Analysis of scenarios in MACMERGE in 10M half-duplex

Lokesh Kabra

Synopsys

Figure 99-5—Transmit Processing state diagram

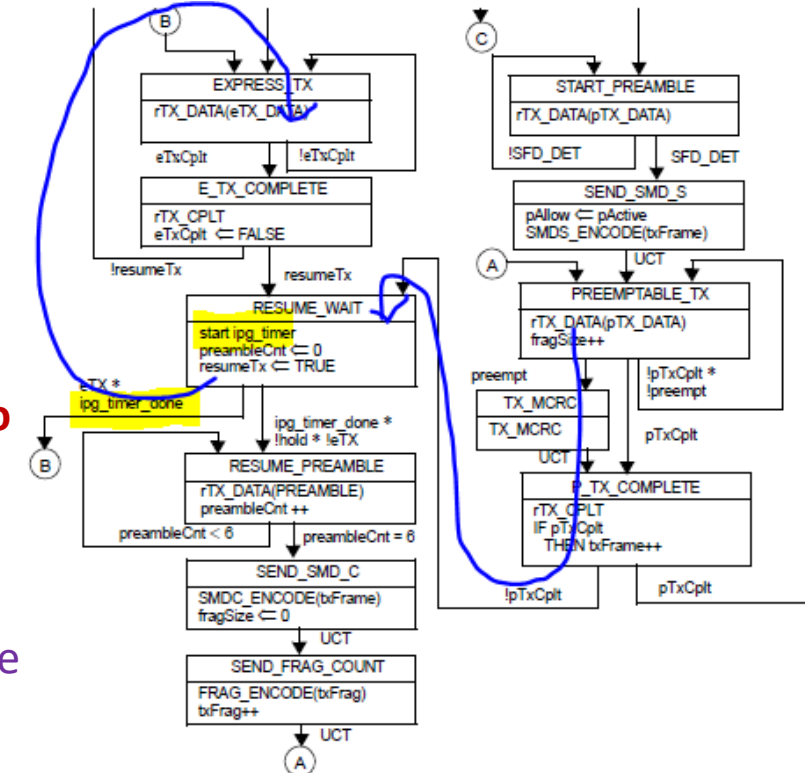
- Considering that Clause 99.4.4 is fixed as proposed in previous slide, it has a side effect as explained below
- When pMAC1 is pre-empted by eMAC1, the state machine transitions as shown with a IPG period of 96bits in RESUME_WAIT state during which there is no data transfer and line is IDLE
- This makes the CRS go low for the which in turn makes the pPLS_CARRIER.indication as “CARRIER_OFF”. This will **result in the pMAC to increment the “aCarrierSenseErrors” counter for the pre-emption event.**

- The MM sets the pPLS_CARRIER.indication as “CARRIER_ON” when the state enters P_TX_COMPLETE from TX_MCRC with *preempt* (*pTxCplt = 0*)
- It is made same as RS.PLS_CARRIER.indication only when state machine enters IDLE_TX_PROC from P_TX_COMPLETE with *pTxCplt = 1*

Collision Scenarios in MACMERGE - 1

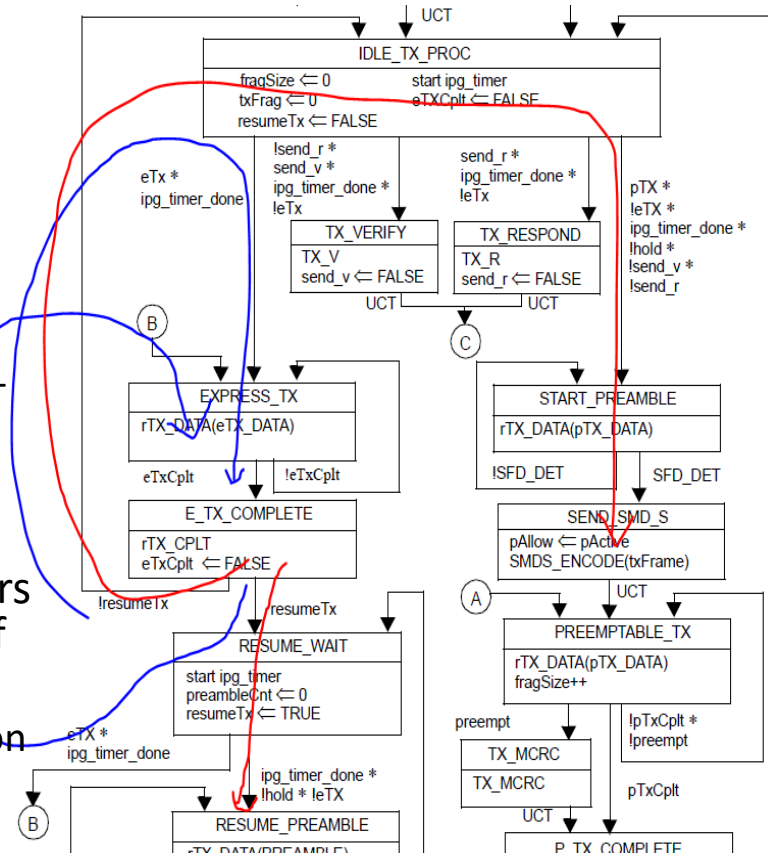
- Collision during Express Frame transmission in **EXPRESS_TX** state
- On collision, eMAC will make $eTxCplt = 1$ & hence state moves to E_TX_COMPLETE

- IPG period of 96 bits in IDLE_TX_PROC or RESUME_WAIT states during which line is IDLE
- 4 possible transition paths as shown
 - a. Blue (okay) paths only when Express packets gets retransmitted due to random-backoff interval = 0 OR pMAC not ready ($pTx = 0$)

- b. Red (not ok) paths when random-backoff interval > 0 and preemptable packets ($pTx = 1$) are in queue
- Impact of “red” path transitions : Transmission of preemptable fragment occurs immediately after min-ipg (ipg_timer_done) while eMAC is in collision/backoff period ($!eTx$).

1. Latency delay of express packet increases due to preemptable packet transmission
 2. Random backoff algorithm intent violated and leads to increased probability of subsequent collisions especially when far-end also has both eTx & $pTx = 1$

- At collision event, if PLS.SIGNAL.indication received from RS is sent as-is to both pMAC & eMAC, then **both MACs will register a collision and back-off**. This should be prevented and only the MAC which was transmitting (selected by MM) at time of collision should get the collision event

Collision Scenarios in MACMERGE - 2

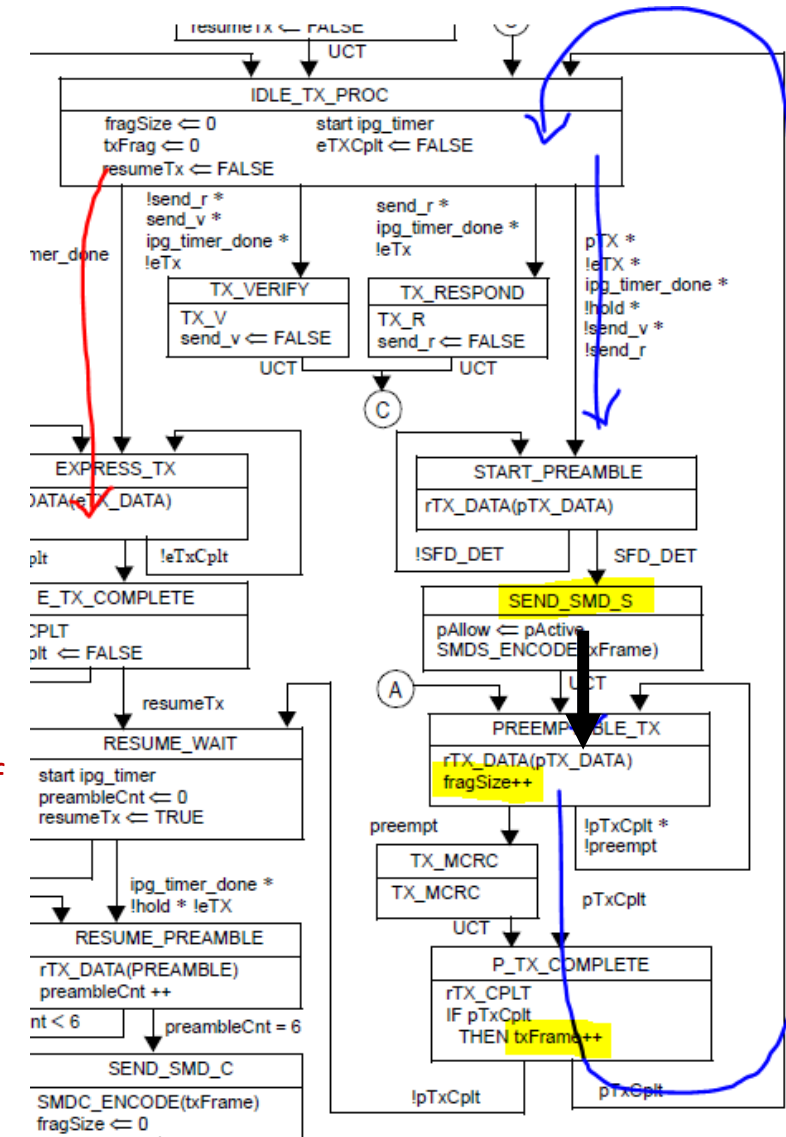
- Collision during Preemptable **SMD-S** (first fragment) frame transmission in **PREEMPTABLE_TX** state
- On collision, pMAC will make $pTxCplt = 1$ & $preempt$ will be 0

- State will move to IDLE_TX_PROC because “pre-empt = 0 & $pTxCplt = 1$ ” after collision and wait for IPG (96 bits) period to be over; After that
 - Blue (okay) paths only when preemptable packets gets retransmitted when $eTx = 0$ after random back-off; Side effect is that $txFrame++$, $fragSize++$ even though the frame/fragment transmission was not successful.

- Red path when $eTx = 1$ during random backoff of pMAC
- Impact of “red” path transition : Transmission of Express packet can occur immediately (after min-ipg) while pMAC is in random-backoff

- Random backoff algorithm intent violated and leads to increased probability of subsequent collisions especially when far-end also has both eTx & $pTx = 1$. However alternative view is that eMAC is pre-empting the pMAC which is the objective of MM & hence it should be okay

Collision Scenarios in MACMERGE - 3

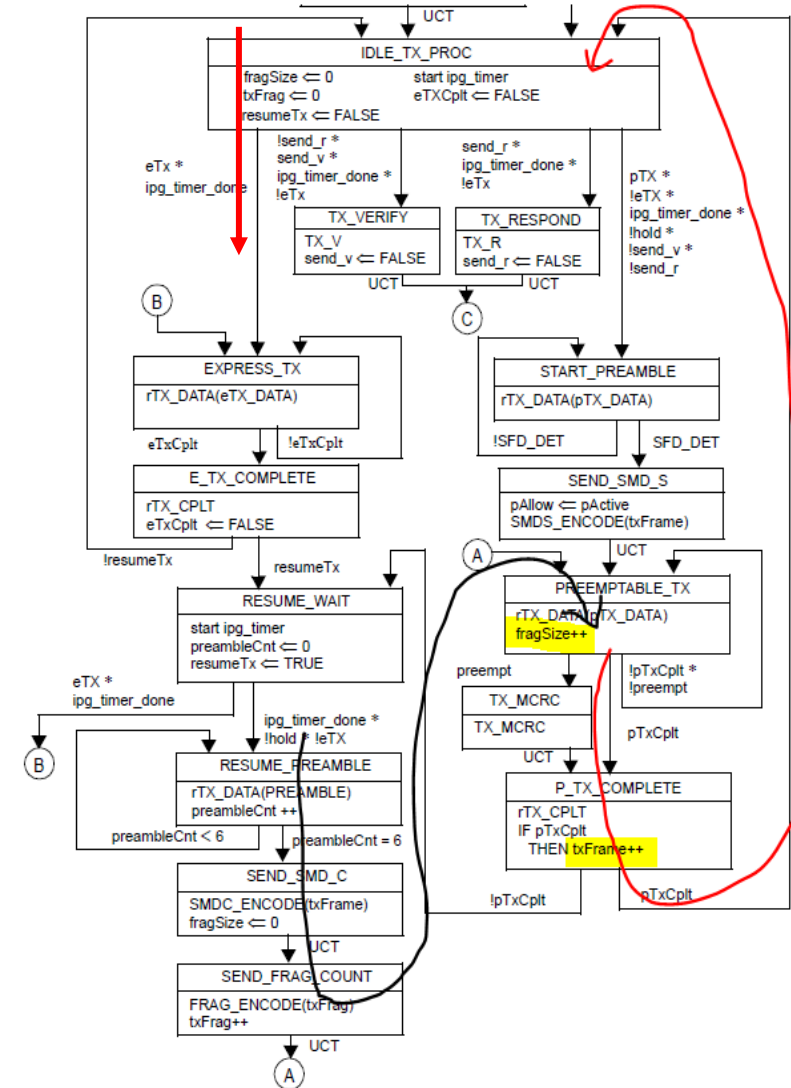
- During Preemptable SMD-C (not first fragment) frame transmission in PREEMPTABLE_TX state
- State will move to IDLE_TX_PROC because “pre-empt = 0 & pTxCplt = 1” after collision; This has major impact
 - pMAC will declare late collision and abort frame transmission because collision occurred after minFrame size (i.e not in first fragment)
- If eTx = 1 after ipg_timer_done, state moves to EXPRESS_TX
 - Random backoff algorithm intent violated and leads to increased probability of subsequent collisions especially when far-end has both eTx & pTx = 1

Figure 99-6—Receive Processing state diagram

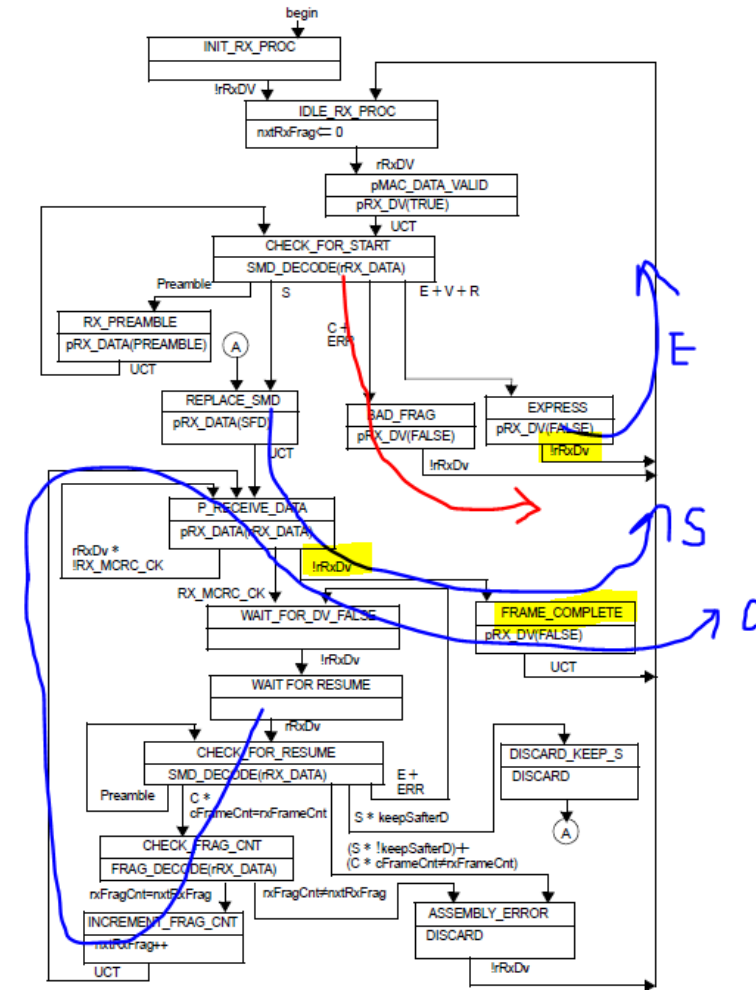
rRX_DV -> 0 prematurely due to collision and backoff by far-end transmitter

1. During Express packet reception (Path E)
 - Okay with no impact
2. During SMD-S Fragment reception (Path S)
 - State machine moves to FRAME_COMPLETE -> IDLE_RX_PROC
 - Hence state machine expects SMD-S again which is okay since far-end will retransmit SMD-S
3. During SMD-C Fragment reception (Path C)
 - State machine moves to FRAME_COMPLETE -> IDLE_RX_PROC
 - If other end retransmits SMD-C, it will discard (red path) because it is now looking for a new SMD-S

Figure 99-5—Transmit Processing state diagram

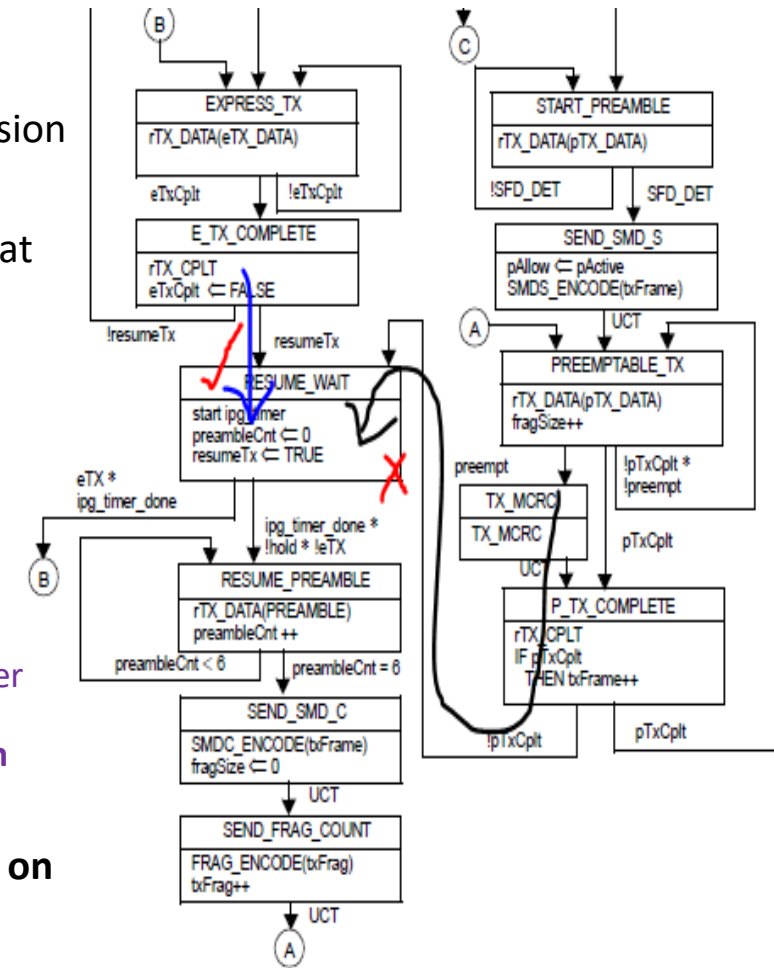
Prevent “late” collisions during transmission of continuation fragment by doing carrier extension & avoid IPG before start of continuation fragment transfer.

- MM transmits Carrier Extension symbol (COMMIT symbol?) in RESUME_WAIT state so that the line is blocked (carrier extension during IPG) before resumption of continuation fragment. This avoids collisions in continuation fragment transfer totally

- Split RESUME_WAIT state into 2 states –
 - RESUME_WAIT_CE (MM transmits carrier extension) :
 - Entry from E_TX_COMPLETE only if express packet transfer completed w/o collision & $resumeTx = 1$

- Same exit transitions as now
 - RESUME_WAIT_NO_CE (w/o carrier extension) :
 - Entry from P_TX_COMPLETE (!pTxCplt) or from E_TX_COMPLETE if express packet transfer resulted in collision

- Exit only to EXPRESS_TX (B) on $eTx = 1$ after random backoff; **This also blocks pMAC from resuming transmission while eMAC is in random backoff**
- This results in IDLE/IPG before transmission of every Express packet which allows **eMACs on both sides an equal opportunity to transmit a packet** after a fragment transfer.

- This also limits the burst on line to a maximum size/delay of 1 express packet + 1 continuation fragment transfer.
- It still allows the local eMAC to pre-empt the pMAC multiple times as desired without further increase of burst size

Suggestions to fix

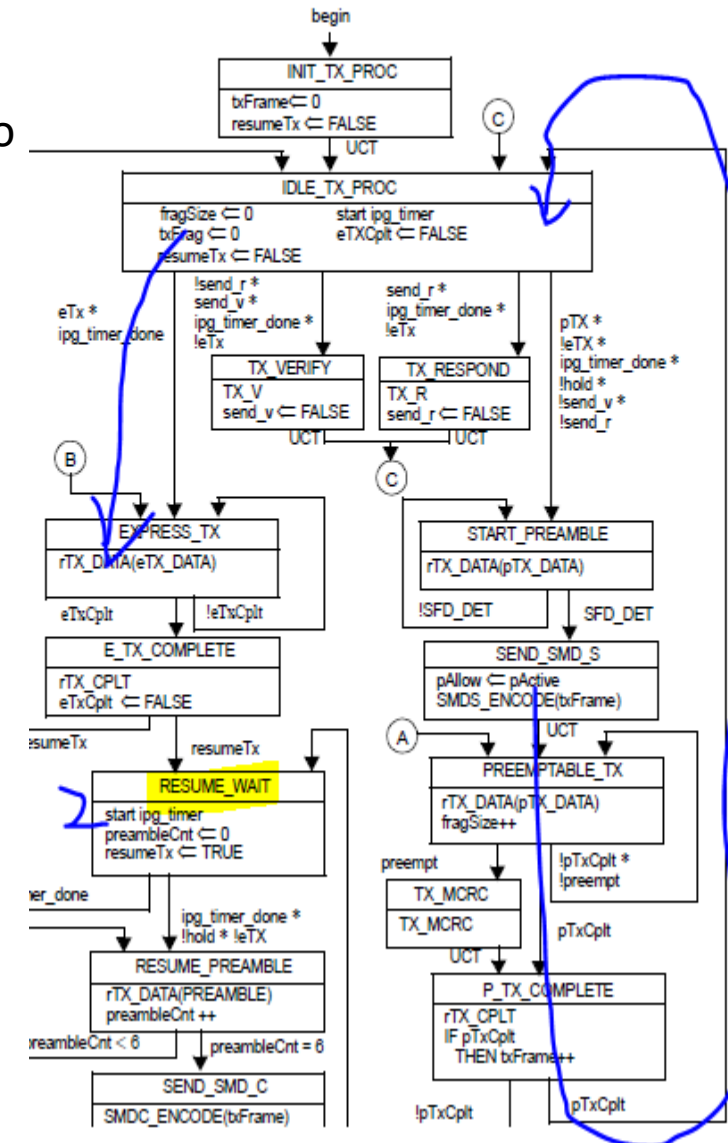
- When Collision occur during SMD-S (first) fragment transfer, state machine moves to IDLE_TX_PROC when pMAC is in random backoff
- If $eTx=1$ after ipg_timer_done, the express packet transfer starts violating the random back-off. But this can be justified because eMAC has higher priority
- If another collision occurs during that express packet transfer, then state moves to RESUME_WAIT_NO_CE as explained in previous slide which ensures that pMAC will not get any further opportunity to transfer until the express packet transfer is completed successfully
- This ensures that during collision backoff at most 1 MAC from either side of the link is participating as intended, after a max of 2 consecutive collisions
- Only caveat is that eMAC1 and pMAC2 (or vice versa) can arbitrate and pMAC can still win the line. This is an inherent nature of half-duplex and can't be avoided.
